General Bid Bulletin No. 5
October 26, 2017

Invitation for Bid No. 17-065-3

***Expansion of the Existing Depot at Baclaran and
Construction of a New Satellite Depot at Zapote for
Light Rail Transit (LRT) Line 1-South (Cavite) Extension Project***

DRAWING STATUS: PRELIMINARY DESIGN STAGE	PROJECT: MANILA LRT1 CAVITE EXTENSION (L1CEP)
SCALE: 1:100	TITLE: BACLARAN DEPOT - TPS EQUIPMENT LAYOUT
FORMAT: A3	DRAWING NO: L1CEP1-EPC-D2-POS-LAY-ARCHII
CNDR REF: L1CEP1-EPC-D2-POS-LAY-XREF	L1CEP1-EPC-D2-POS-LAY-0016

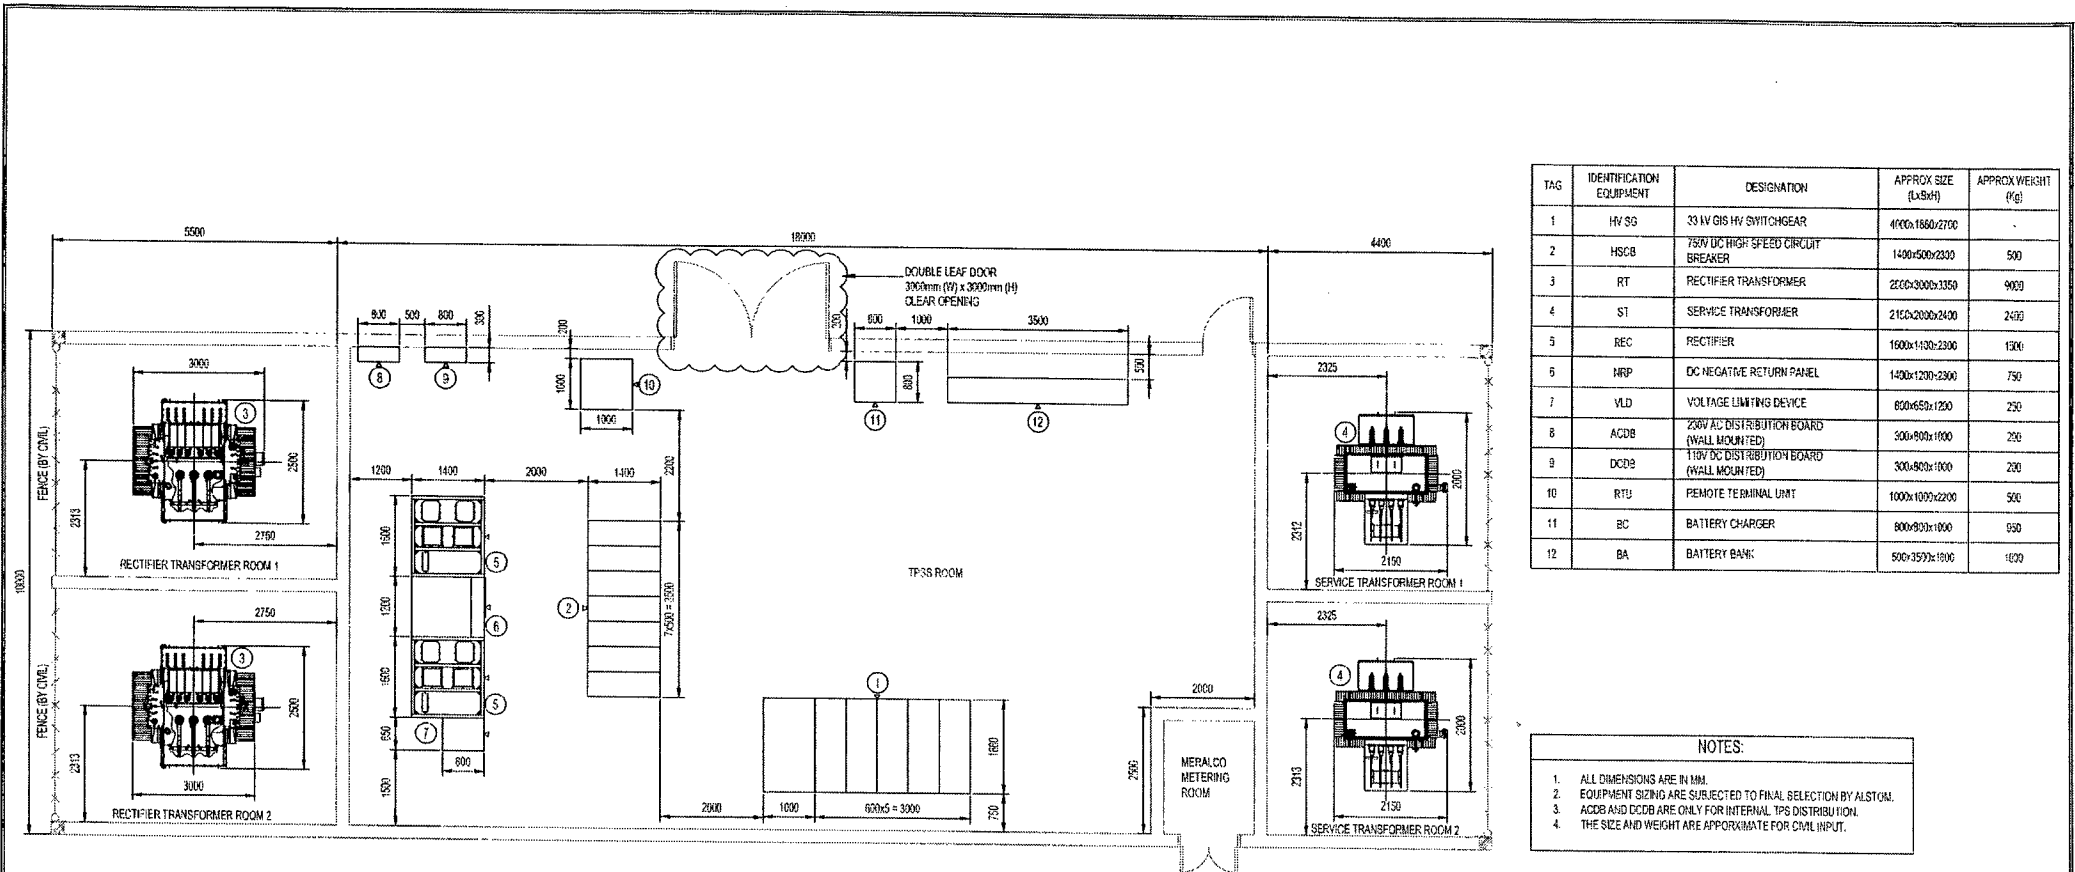
17			Compressed Dry Air System	Please provide Compressed Dry Air (CDA) capacity requirement per equipment needed.	As this is a Design and Build Bidding, the Bidder has the responsibility to coordinate with their equipment sub-contractors/suppliers for compressed dry air capacity requirement per equipment.
18	VI-2		Technical Requirements / Technical Specification/ 4.3.3 Utilities – Electrical Power	"Power supply including transformers and Distribution Switch gear located in the substation is in the scope of EPC Contractor." Transformers are included on EPC scope of work. MV Switchgear is also part of EPC scope of work.	No. Technical Specification (page TS-6) Clause 4.4.3 Low Voltage Interface Works with EPC, states that the Contractor shall be responsible for the cable to the main isolator in the Substation and the feeder breaker downstream located in the switch room. Therefore supply

<p>Thus, in relation to General Bid Bulletin No. 16, supply and termination of MV cables connecting the MV switchgear & transformer is not included in the contractor's scope of work.</p> <p>Please confirm.</p>	<p>and termination of cables connecting from the output of EPC switchgear/transformer is included in the Contractor's Scope.</p>
19	VI-2	Technical Requirements / Technical Specification/D. Building E&M Work	<p>"Note: The following works are excluded from E&M Building services... a) HV/MV Supply Power;"</p> <p>Please provide details on the substation for the following for structural design consideration and cabling route:</p> <ul style="list-style-type: none"> a. HV/MV equipment layout on the substation (switchgear, transformers, etc.) b. Equipment loading 	<ul style="list-style-type: none"> a. HV/MV equipment layout on the substation (switchgear, transformers, etc.) is attached for reference. b. Equipment Loading for the Baclaran Depot Sub-station is shown on the attached drawings. For Zapote Depot Sub-station, the equipment loading is not yet available.
